18<sup>th</sup> January 2022  
Your Ref: 2021/0321/P  
My Ref: 21082

**Town and Country Planning Act 1990 (as amended)**  
**2021/0321/P and 2021/1968/L – Planning and Listed Building Consent applications for light refurbishment of all floors including installation of air conditioning systems**  
**27 Fitzroy Square W1T 6ES**

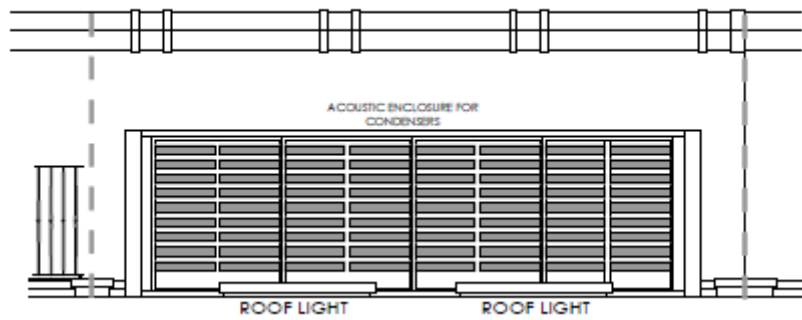
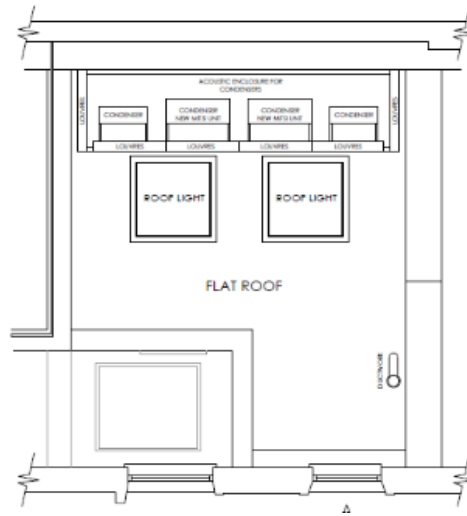
*Your email referred to the air-conditioning units approved 07/08/2018 at 28 Fitzroy Square (planning ref: 2018/1361/P). It is unclear whether the case officer considered Policy CC2 as there is no reference to this policy in the Delegated Report. It is also evident that the development approved at 28 Fitzroy Square was not comparable to that proposed at Number 27 which involved the demolition of the first-floor element and the re-provision of this volume at ground floor to make the existing ground floor half width extension full width. Therefore, the reconfiguration of floorspace involved the loss of rooms with windows providing natural ventilation to a full width extension without natural ventilation.*

Therefore, it is clear that there is precedent for air conditioning units which has been created in the immediately adjacent property for which planning permission was granted on 7<sup>th</sup> August 2018 for 'rear extensions at ground floor level including roof terrace and new access door above following the demolition of first floor rear projection. Refurbishments to building incl. lowering of floor to front vault and installation of new AC plant all in association with the continued use of the building as an office (B1a)' (Ref: 2018/1361/P).

Furthermore, submitted drawing 263-001(P1F)ELE-01A shows the location and size of the proposed condenser units and enclosures as follows:

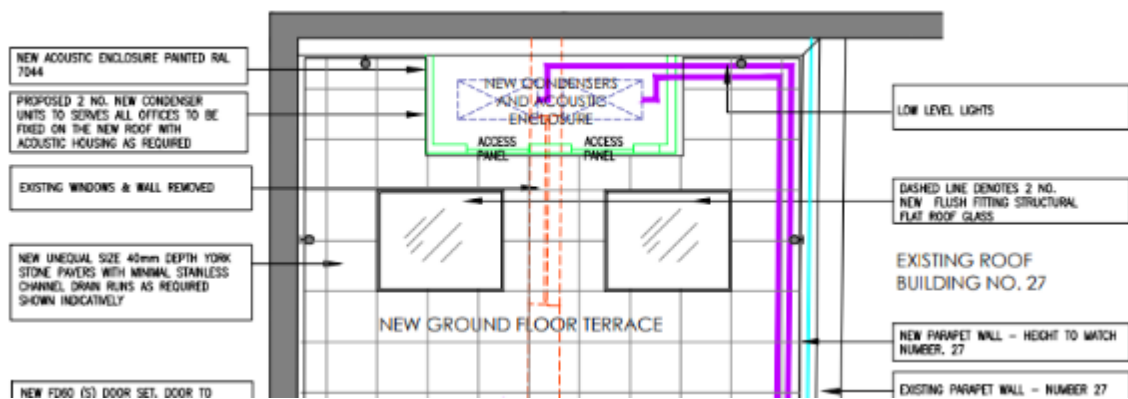
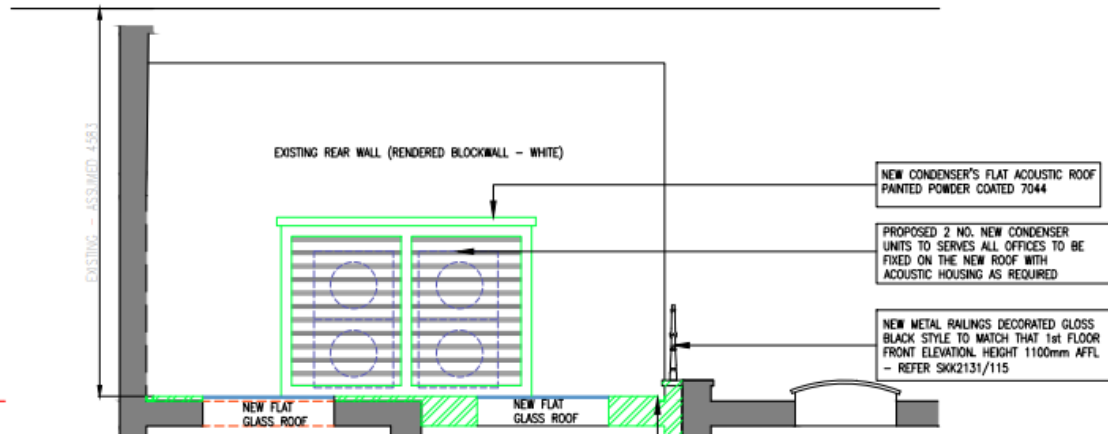
*The size of this enclosure is also a concern. It appears to be significantly larger than that approved at Number 27. The enclosure approved at Number 27 measured approximately 3m by 1.1m and was 2.1m high. Whereas the enclosure sought at the subject property would be approximately 5.8m by 1.47m and would be 1.66m high.*

It is assumed you are referring to No. 28 when discussing the approved enclosure. However, when referring to the 2020 consent and the photograph above it is clear that the current proposal is the same as the one which was approved at No. 28 and, in fact, the current proposals were deliberately designed to match this adjacent property.
